SERVICE BULLETIN

B-032

PRODUCT PROGRAM BP7 - EXHAUST HEADER MOUNT RETROFIT KIT

Figure 1. Modified Exhaust Mounting System (1999-2000 Models)

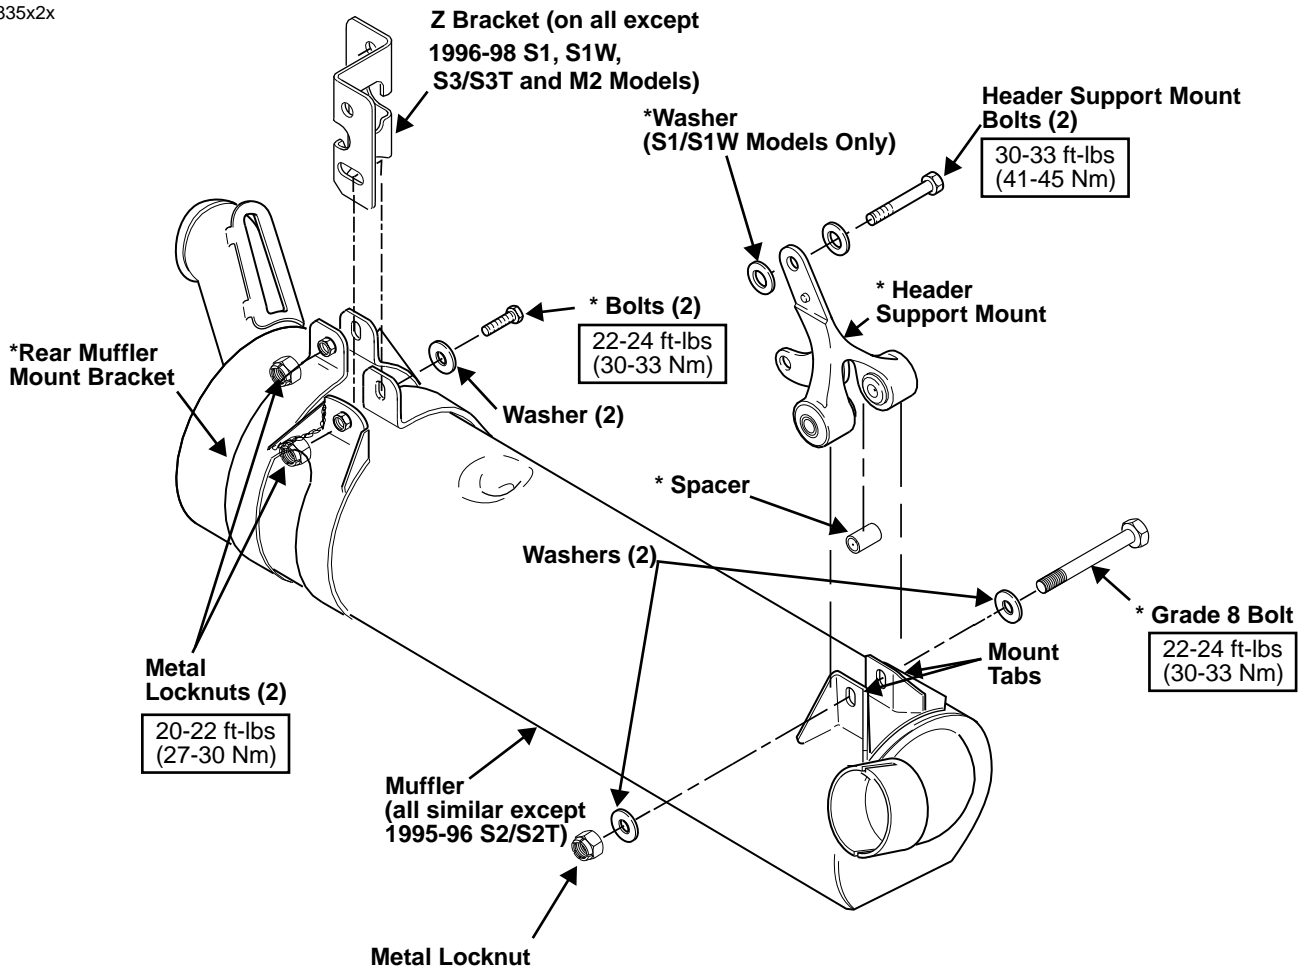
The purpose of this bulletin is to announce the release of a **new** kit for all 1995-2000 S1, S1W, M2, S2/S2T, S3/S3T, and X1 Model Buell motorcycles and to provide installation instructions. Buell Motorcycle Company has developed this kit as an upgrade to the exhaust header mounts currently in use.

- c. See Figure 1. Apply LOCTITE THREADLOCKER 243 (Blue) to threads of two original header support mount bolts. Install voltage regulator bracket/header support assembly with two original header support mount bolts and washers (and locknuts if present). DO NOT tighten.
 - d. Apply LOCTITE THREADLOCKER 243 (Blue) to threads of original small button head allen screw and install to voltage regulator bracket and shock mounting bracket. DO NOT tighten.
 - e. See Figure 4. Check voltage regulator bracket to verify that pin remains engaged in hole and that bracket does not pivot front to rear.

10. **S1/S1W Models Only:** See Figure 1. Install **new** washer (provided in kit) over hole at top of the header support mount (between header support mount and crankcase). Install header support mount with two original header support mount bolts and washers.

12. **1999-2000 Models Only:** See Figure 1. Remove and discard muffler mount from rear of muffler and install **new** muffler mount.
 - a. Remove two screws, lockwashers and washers from rear exhaust mount and Z bracket. Discard screws and lockwashers. Retain washers for reuse.

- b. Push rear of muffler down slightly and remove (slide off) and discard original rear muffler mount bracket.
 - c. Slide **new** rear muffler mount bracket over muffler and install with two **new** grade 8 bolts (provided in kit), original washers and **new** metal locknuts. NOTE: Install two metal locknuts over weldnuts on right side.

- d. Tighten rear muffler mount bracket bolts to 22-24 ft-lbs (30-33 Nm).
 - e. Tighten rear muffler mount bracket metal locknuts to 20-22 ft-lbs (27-30 Nm).

Figure 2. Original Exhaust Header Mount (1999-2000)

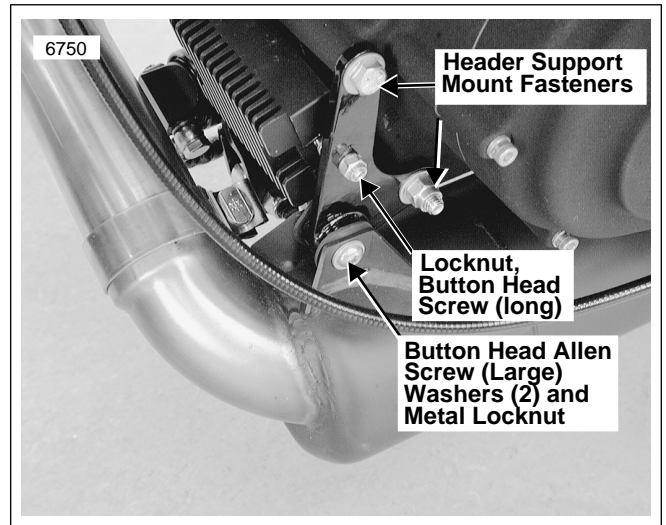
6. See Figure 3. Position bottle jack under swing arm mount block and raise motorcycle just enough to unload rear suspension (rear wheel remains on lift).
7. Remove and discard header support mount from muffler and crankcase.
 - a. See Figure 2. Remove large button head allen screw, two washers and metal locknut from header support mount. Discard screw. Retain washers and locknut for reuse.

- b. See Figure 2. Remove two header support mount bolts, washers, locknuts (if present) and header support mount, allowing shock mounting bracket (attached to front shock eye) to hang free. Discard header support mount. Retain washers and two bolts.
8. Inspect muffler inlet, O₂ sensor bung (if present), mounts and fasteners for cracks or damage. Replace damaged parts as required. See Credit Procedure.

Figure 4. Voltage Regulator Bracket

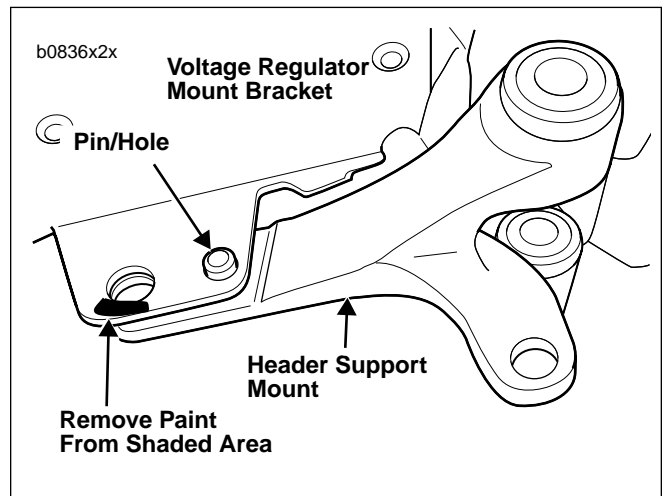
Scraping the paint from the voltage regulator bracket is required to ensure a good ground for the voltage regulator.

- a. See Figure 4. Scrape paint from inside corner of voltage regulator bracket on crankcase side.
- b. See Figure 4. Position **new** header support so pin engages hole in new voltage regulator bracket.

Figure 5. Header Support Mount (all except S1/S1W)

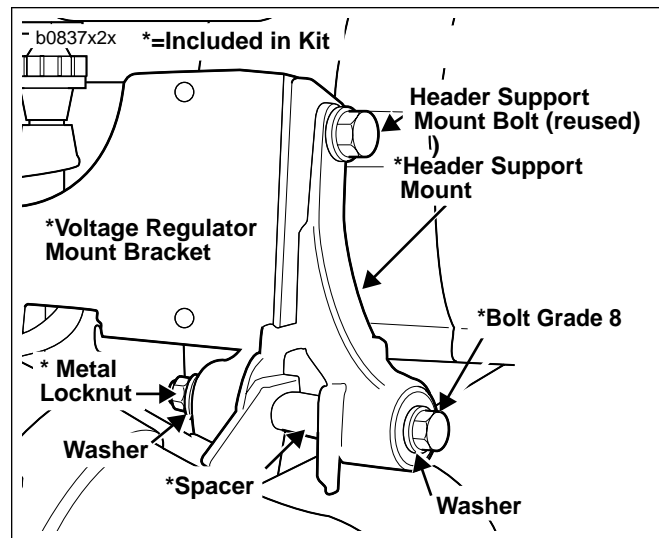
11. See Figures 1 and 5. Install **new** grade 8 bolt, original washer, **new** spacer, original washer and metal locknut to header support mount. NOTE: Spacer goes between front muffler mount tabs.

Figure 6. Voltage Regulator Revised Mounting

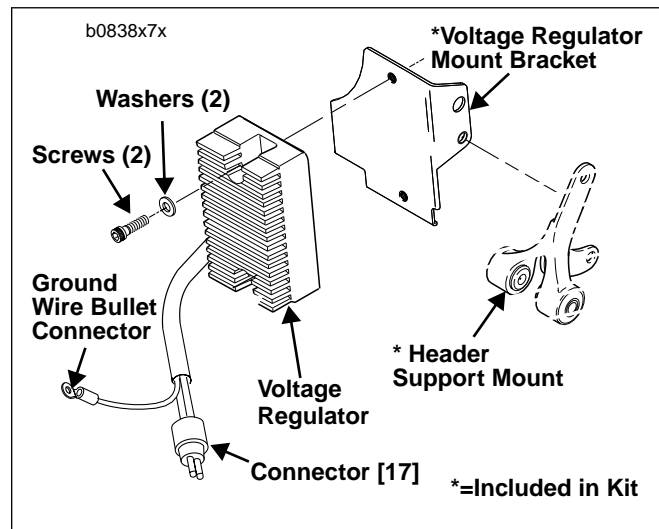
15. See Figure 6. Install voltage regulator.
 - a. Install voltage regulator to **new** bracket with original socket head screws and washers. Tighten screws to 9-11 ft-lbs (12-15 Nm).
 - b. See Figure 7. Route voltage regulator wire harness between shock mounting bracket and oil line.
 - c. See Figure 8. Mate connector [17] halves and secure with cable tie.
 - d. See Figure 6. Connect ground wire bullet connector to main wire harness.
 - e. See Figure 8. Push connector [17] behind gearcase cover and secure connector [17] to oil pump fitting with cable tie.
 - f. See Figure 8. Secure voltage regulator wire harness to oil line and oil pressure switch harness with cable tie.
16. Reconnect battery negative cable to negative terminal. Tighten terminal to specification given in service manual for model being serviced.
